TRUCK, LIGHTWEIGHT AND TRUCK, LIGHT – ALL TYPES – LAND ROVER 110 4X4 AND 6X6

RECTIFICATION OF RADIUS ARM MOUNTS ON FRONT AXLE HOUSING

MISCELLANEOUS INSTRUCTION

Figure 1 Adding Spacers to Radius Arm Mounts

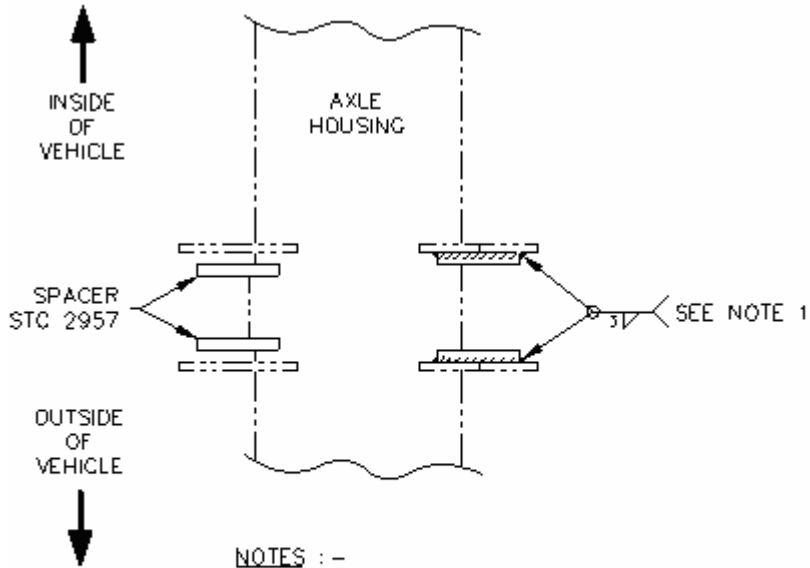
- b. Remove all surface protection coatings from the repair area for a distance of 25 mm in all directions, using either a grinder, sander or file.
- c. Fit Items 1 and 2 from Table 1 to the axle assembly mounts, as shown in Figure 1, using the bolt to align the holes in the spacer with the holes in the locating plates. Clamp the spacers in position against the inside surface of the locating plates and remove the bolt.

- d. Tack weld the spacers in position using the consumables specified in Para 15.f.
- e. Remove the clamps.
- f. Weld the spacers to the inside surfaces of the mount plates, as shown in Figure 1, with a 3 mm continuous fillet weld using either of the following processes:
 - (1) the manual metal arc welding (MMAW) process using electrodes that conform to AS/NZS 4855: E4819; or
 - (2) the gas metal arc welding (GMAW) process using consumables that conform to AS/NZS 2717.1: ES6-GC/M-W503AH and using shielding gas that conforms to AS 4882:SG-ACO-16/2.75.
- g. If the radius arm mounts have been previously reclaimed by welding a collar and nut to the outside of the locating plates (Figure 2), remove them using a grinder. Take care not to remove parent metal from the locating plates.

- NOTES :-
1. EDGE IS TO BE BUILT OUT TO ENSURE DESIGN THROAT THICKNESS (2.1) IS ACHIEVED.
 2. NEW WORK IN FULL LINE EXISTING WORK IN CHAIN LINE

Figure 2 Radius Arm Mounts Showing Previous Reclamation Work to be Removed

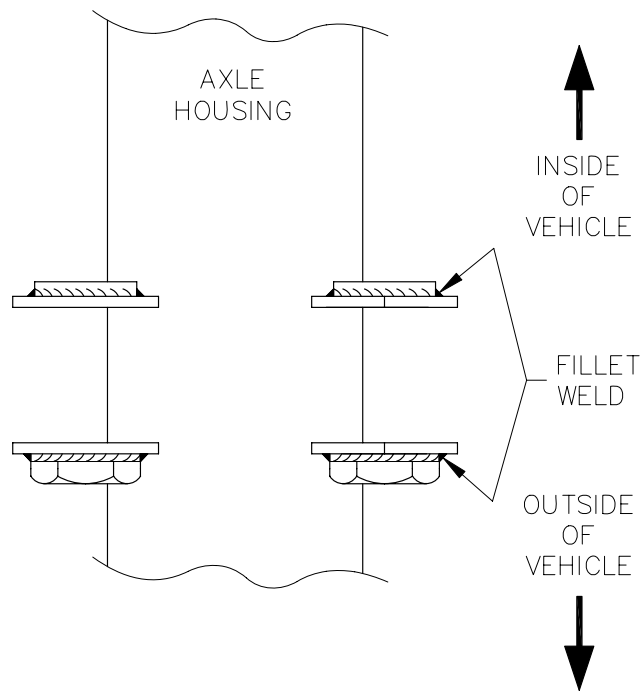
Ensure any collars and nuts that have been welded to the outside of the locating plates, as part of previous reclamation work, are removed.
